Schedule of Proposed Changes to the Wychavon Town Spatial Framework SPD

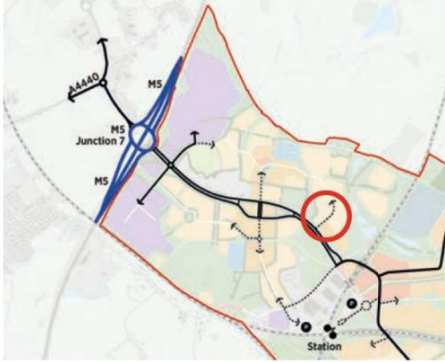
Item 5.1 Movement Strategy Statements and Aim + Figure 18 on page 32 The words and map include Primary Active Travel and Leisure Focused Active travel routes; but there is no reference to existing PRoW or provision for horse riders and disability groups.	Commments noted. A reference to be added to existing PROW provision and users at the end of the first paragraph	Amend p 32 first paragraph as follows: All proposals for improved connectivity across Wychavon Town will fully consider the relationship with existing public rights of way and ensure the provision of equestrian users and the needs of disabled users are understood and provided for.
	Page 33 – Movement Framework “Structuring Elements” table	Comments noted. All existing PRoW will be fully considered as part of any detailed planning application submitted at Wychavon Town to ensure impacts are

Once again, horse riders are not included, so WLAF would like to reiterate the concerns raised in Item 7 above about what might be lost. We would also like additional clarification that neither elements of the new internal road system or the proposed Active Travel routes will create new barriers for path users – eg. housing estate access roads without safe crossing points.	mitigated where possible or if there is a need for rerouting of existing paths this is done with full consideration of all users. All the statutory consultees will be consulted on all applications for the site.	
	Page 34 - Active Travel Networks While Figure 19 does mention existing PRow that will be upgraded and/or re-routed, it doesn't show all the PRow in the site area and/or PRow that will be extinguished where they are overlaid by new roads or Active Travel routes. Once again, where new bridleways are intended, there is no mention of making them shared use routes or requiring their design to meet the needs of horse riders and disability groups.	Comments noted. No further changes to the SPD required.

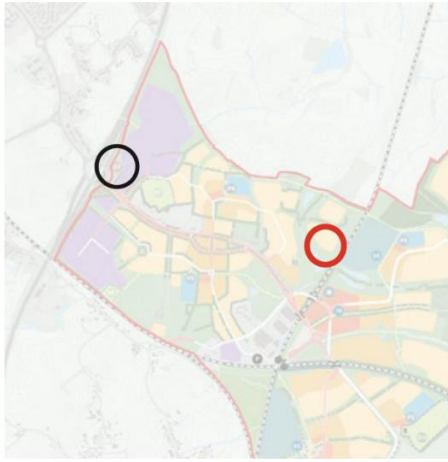
which is partly the reason why employment uses are provided here rather than other forms of residential use; d) The land is proposed for employment uses; and e) The proposed primary substation serving the wider WT new settlement is proposed to be located here. In accordance with the PPTS and the Council's own evidence, if there is sufficient need for G&T and Wychavon Town, sites should be located towards more tranquil areas away from the motorway, but with potential for good connectivity. There is potential for the site to be located closer to the station and town centre, as shown in the figure below.		
--	--	--	--

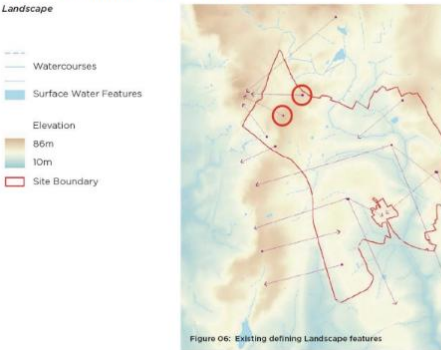
Figure 3: Proposed relocation of G&T site west of the railway (Policy SWDPR 55 location circled black, revised location circled red) 		
	Early employment development enables a functional day-to-day economy from the outset, and it would ensure that employment land is not back-loaded in a manner that undermines the long-term spatial strategy. The aims of the phasing and infrastructure strategy should incorporate the following text with a new bullet point: <u><i>‘Support the early delivery of employment land to ensure that job-creating uses come forward, helping to establish a balanced, sustainable community from the outset.’</i></u>	Noted no change to the SPD required. The SPD cannot control when applicants choose to submit applications and as such developers have already submitted applications to bring forward employment land suggesting there is a desire to see it delivered early in the development of Wychavon Town.
